**Re: A request by Harmony Enterprises for approval of the Preliminary Plat of Harmony Hills Estates 2<sup>nd</sup> Addition, a proposed 11-lot residential subdivision located in part of the SE<sup>1</sup>/<sub>4</sub> of the NE<sup>1</sup>/<sub>4</sub> of Section 26, Blue Grass Township.**

PRELIMINARY PLAT

HARMONY HILLS ESTATES SECOND ADDITION

PLANNING & ZONING COMMISSION  
STAFF REPORT  
August 19 2008

PRELIMINARY PLAT

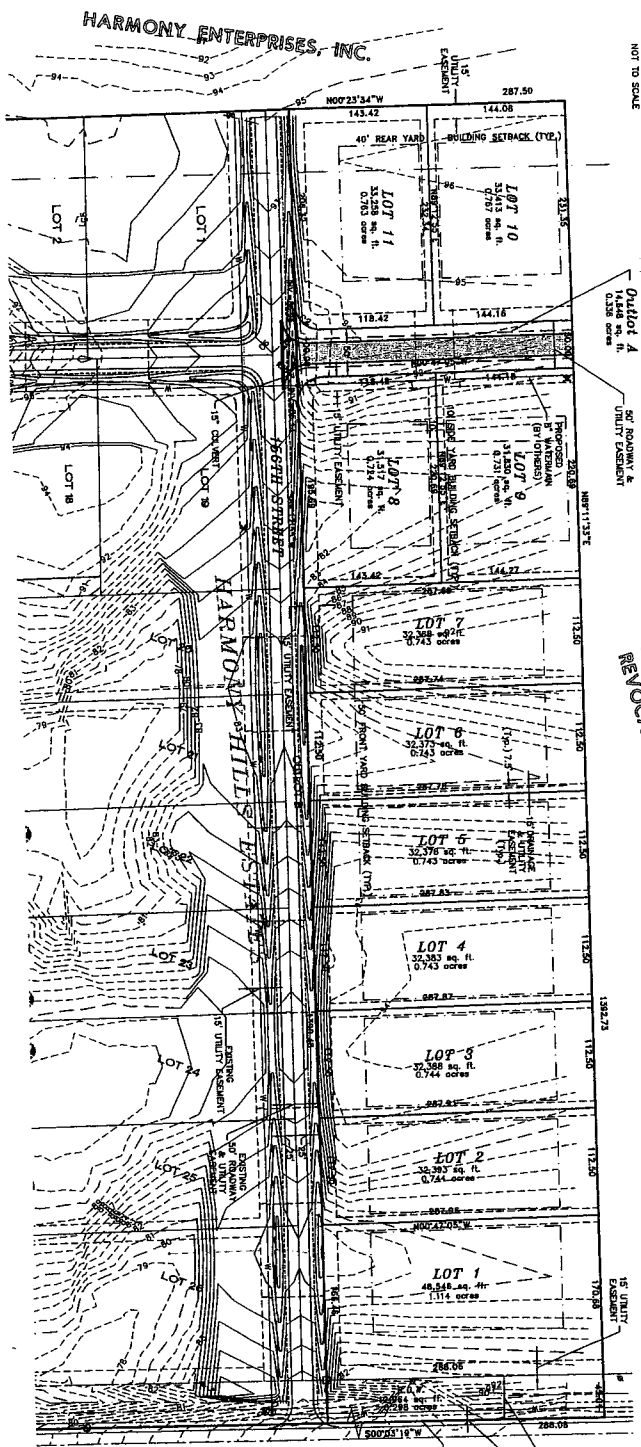
**STAFF REVIEW:** Staff has reviewed this Preliminary Plat for compliance with the Subdivision Regulations. This plat loads the north half of 156<sup>th</sup> Street with eleven (11) additional lots. It also shows a street being extend at the west end of 156<sup>th</sup> Street to provide a future connection to the adjacent undeveloped property. Until such time as the approximately 40 acres of land to the north is developed the existing road that was constructed during the first phase of this development would serve as the developments only access to Y-48.

The applicant's engineer has not, as of yet, submitted an erosion and sediment control plan. The County Engineer will review those plans when submitted. The Natural Resources Conservation Service will also be asked to review those plans. The developer is also required to obtain a State permit from the Iowa DNR for grading an area of this size. Staff has requested a copy of that permit also be submitted

The Health Department has reviewed this plat and stated that they have no major concerns. They did note that soil percolation tests will be required after site grading is completed and prior to Final Plat approval.

1. The City of Davenport also review and approve the Preliminary and Final Plat prior to Final Plat approval by the Board of Supervisors;
2. That no Final Plat that would result in greater than fifty (50) total lots for any portion of the Harmony Development be approved until a second access is provided;
3. The stormwater drainage and erosion control plan be reviewed and approved by the Soil Conservationist at the NRCS;
4. The proposed wastewater treatment facilities meet Health Department requirements;
5. The County Engineer review and approve all street construction plans prior to construction; and
6. The subdivision infrastructure improvements be completed or a surety bond posted prior to Final Plat approval.
